Gatecheck Report as issued to the Energy Consents Unit in September 2020

Harestanes South Windfarm Extension

Gatecheck Report

Harestanes South Windfarm Extension
Figure 3.1 Design Iteration of Turbine Layouts A, B and F

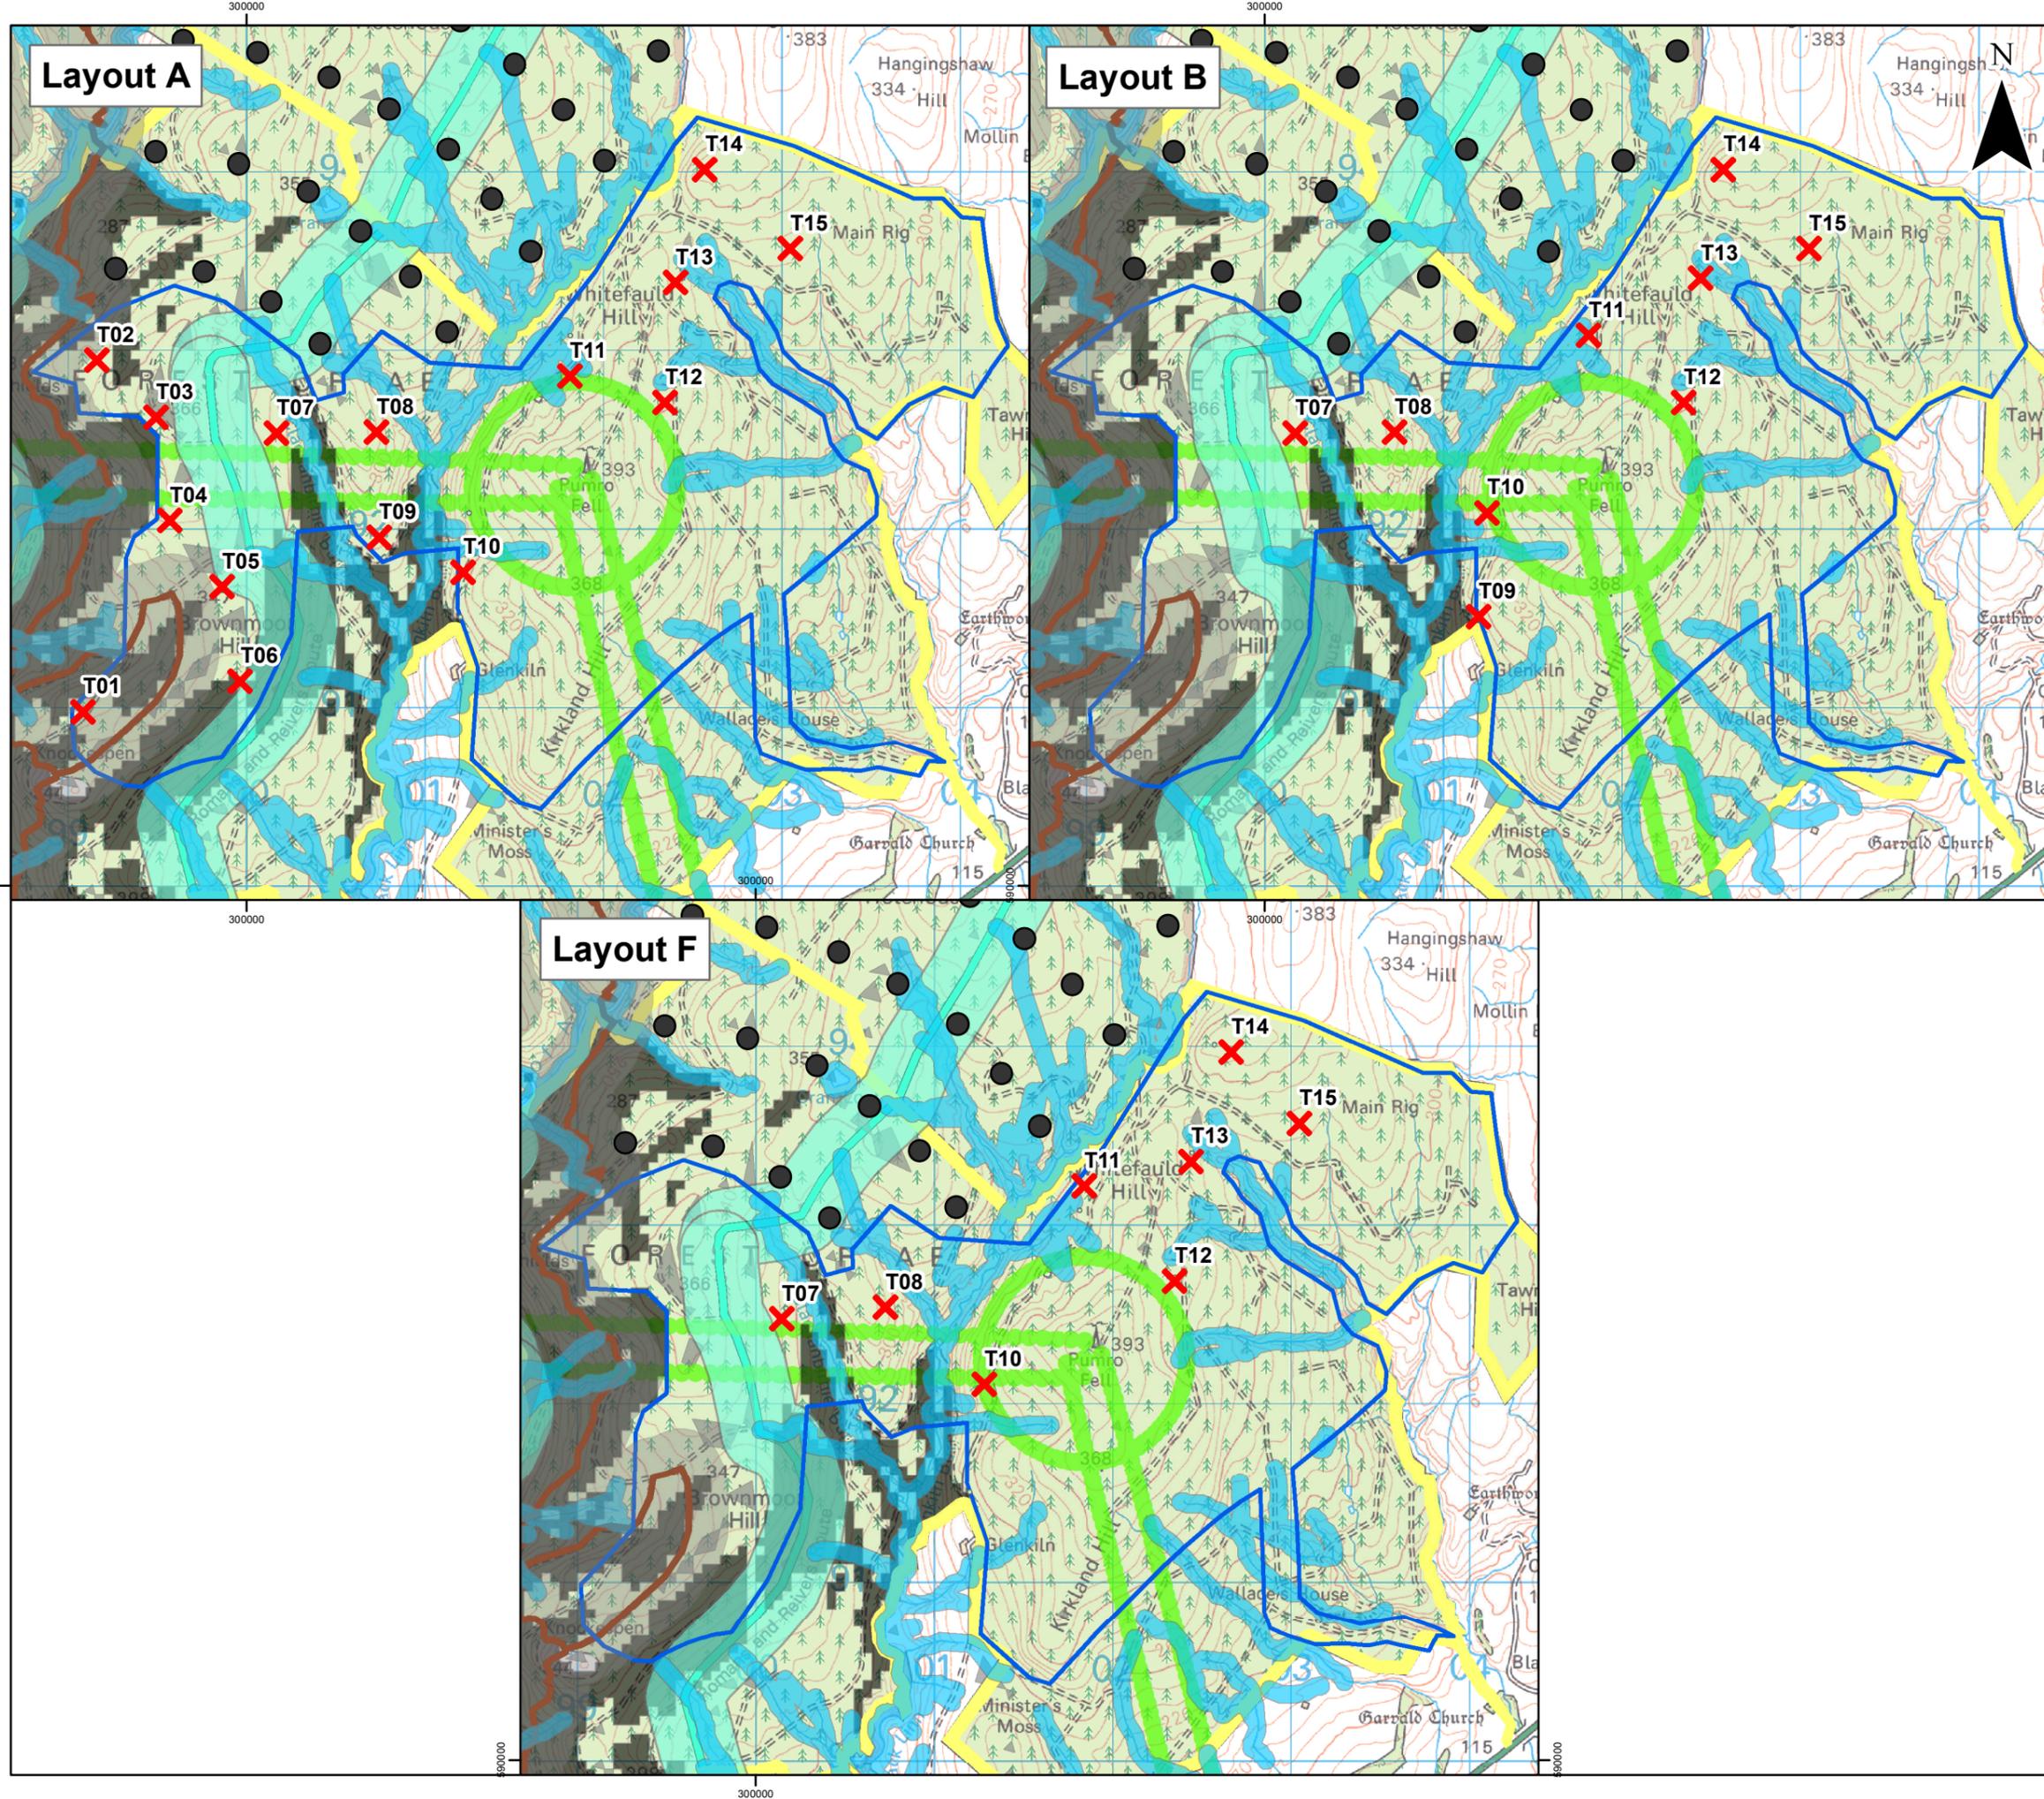
Consultee	Scoping Comment	Scoping Opinion Ref.	Response
ECU	It is acknowledged that the environmental impact assessment process is iterative and should inform the final layout and design of proposed developments. Scottish Ministers note that further engagement between relevant parties in relation to the refinement of the design of this proposed development will be required, and would request that they are kept informed of on-going discussions in relation to this. Applicants are encouraged to engage with officials at the Scottish Government's Energy Consents Unit at the pre-application stage and before proposals reach design freeze	Section 5.4 & 5.5	A meeting was held on 7 May 2020 with the ECU, Dumfries and Galloway Council, NatureScot and SEPA during the EIA Scoping consultation period to discuss the proposals. A follow-up on-site meeting was offered to the ECU and statutory consultees which took place before design freeze, and was attended by Dumfries and Galloway Council Planning Case Officer and NatureScot Officer.

SEPA	The layout should be designed to minimise the extent of new works on previously undisturbed ground	Page A38	The design has sought where possible to use existing infrastructure such as the existing forestry tracks and construction compound, site access, borrow pits and substation from the operational Harestanes Windfarm.

10. Environmental baseline information has been gathered for the site by the Applicant and project team to identify a design layout that considers the environmental constraints identified and the consultee responses received to date. **Chapter 3: Site Selection and Design** of the EIA Report will outline the design iterations which have occurred prior to the finalised design of the Proposed Development. The key layout iterations are summarised in **Table 3.2** and illustrated in **Figure 3.1: Design Iteration of Turbine Layouts A, B and F**.

Layout	Description	Design Rationale
A	Scoping Layout (15 Turbines)	<p>A Developable Area (the envelope which constrained the location of main windfarm infrastructure) was initially defined, which took into consideration a number of factors including a 1km off-set from residential properties and an off-set of approximately 2km from the A701 due to visual considerations.</p> <p>Constraints taken into consideration at this stage included watercourse buffers, telecommunication fixed links, Core Path and 7stanes bike trail buffers and initial visual consideration to exclude the most obvious 'outer slopes' of the site to the south east.</p> <p>This layout was used for the EIA Scoping consultation stage.</p>
B	Refined Turbine Layout following first design workshop (9 Turbines)	<p>Following early consultation, turbines at the western end of the site were removed to avoid the 7Stanes mountain bike trail centre, remove visual impacts from Ae and potential noise impacts to Craigshields recreation centre. This also removed turbines which were encroaching on the outer slopes (or exterior) of the site and with proximity to local residents.</p> <p>The remaining turbines were re-positioned to optimise the site for peat constraints and landscape and visual factors such as gaps, stacking, outliers, scale comparison against operational Harestanes turbines and visibility against Queensbury.</p>

F	Final Layout (8 Turbines)	<p>Following further consultation, turbine 9 was removed due to a combination of environmental and technical factors. There were visual effects due to its position on the 'outer' slopes of the Site and also in relation to extensive cut and fill requirements for this location due to the slope gradient. This region of this site also has high bat activity and therefore it was decided that this turbine be removed.</p> <p>Turbine 15 was moved to the east to provide an off-set to a grave site and maintain its forest clearing setting; and to avoid a potential bat roost site.</p> <p>Turbine 12 was microsited to improve its position in relation to peat and mire habitat.</p>
